WIRING DIAGRAM FOR REPLACING A.C. BRAKE WITH 16"-18" OR 20" H.W. D.C. BRAKE

S-10,019-1

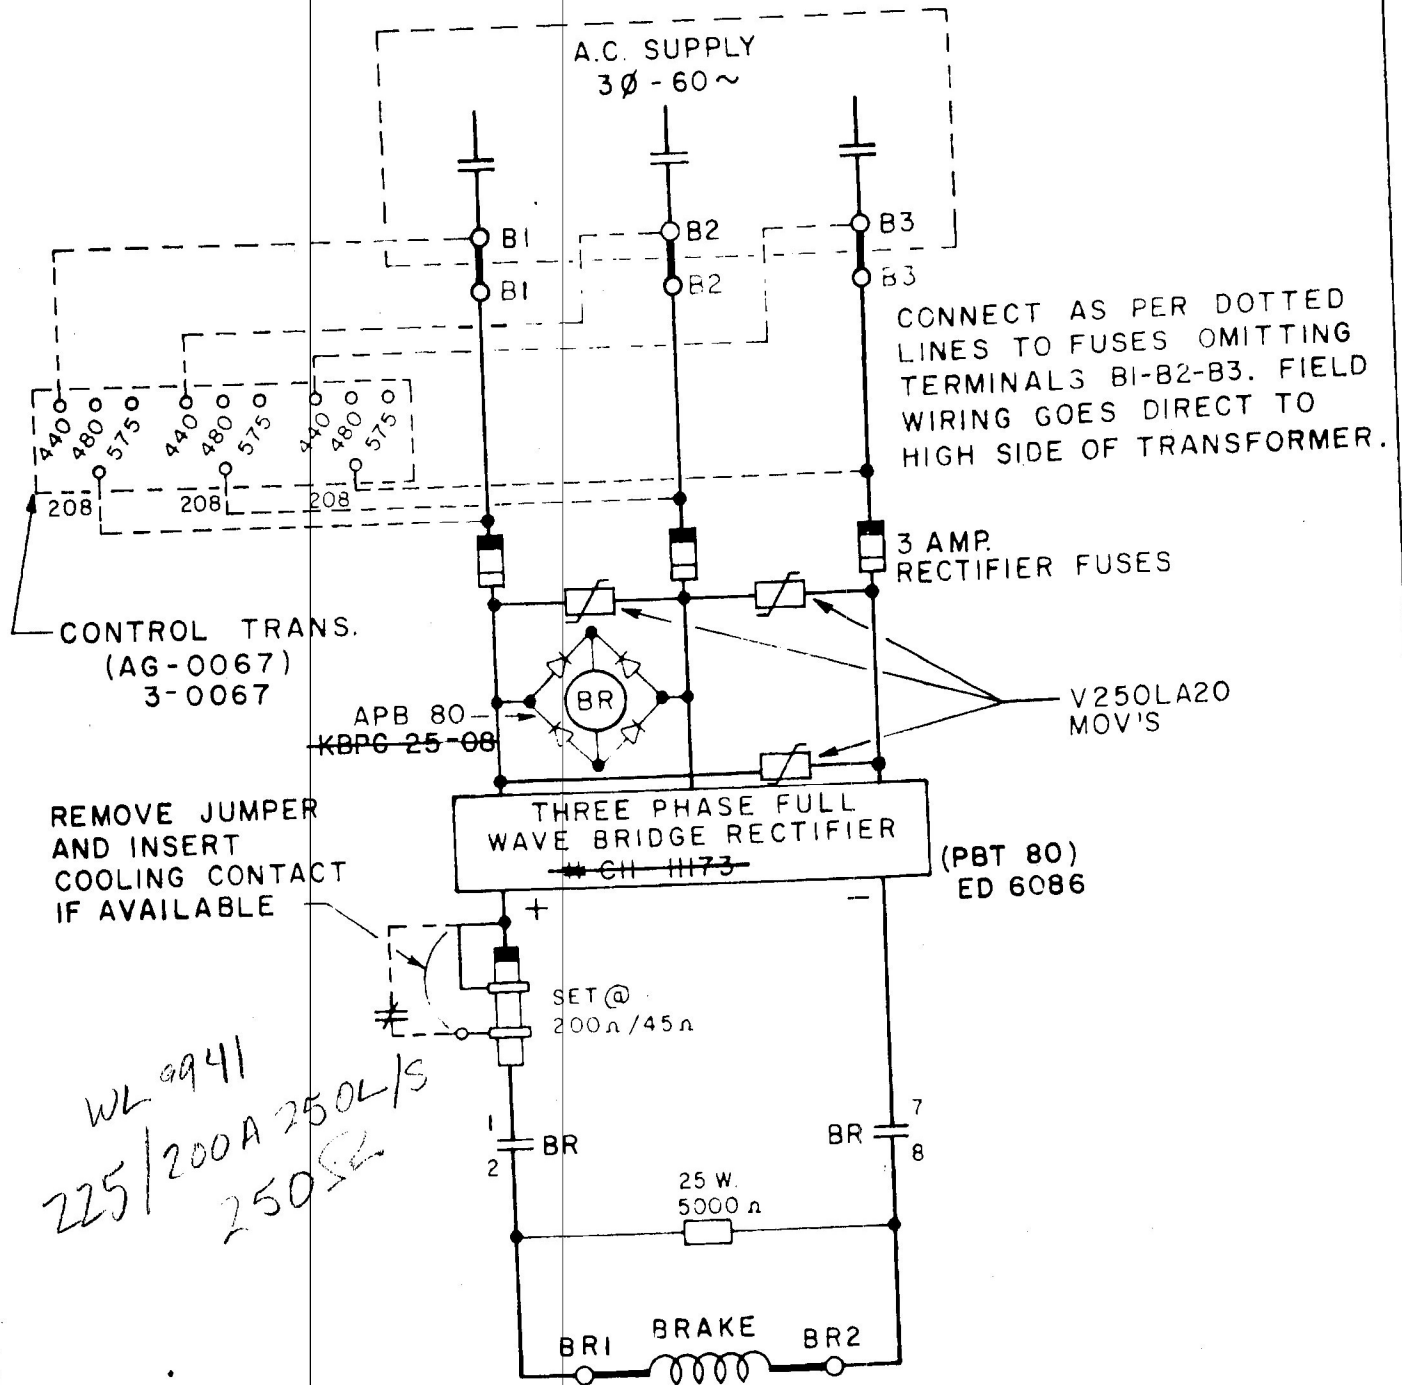
REVISED 5/21/75  
"BR" RELAY WITH COIL 5693 REPLACED WITH FABRICATED RELAY USING COIL S6438 23000T 39 W AND RELAY RECTIFIER K9H 2506
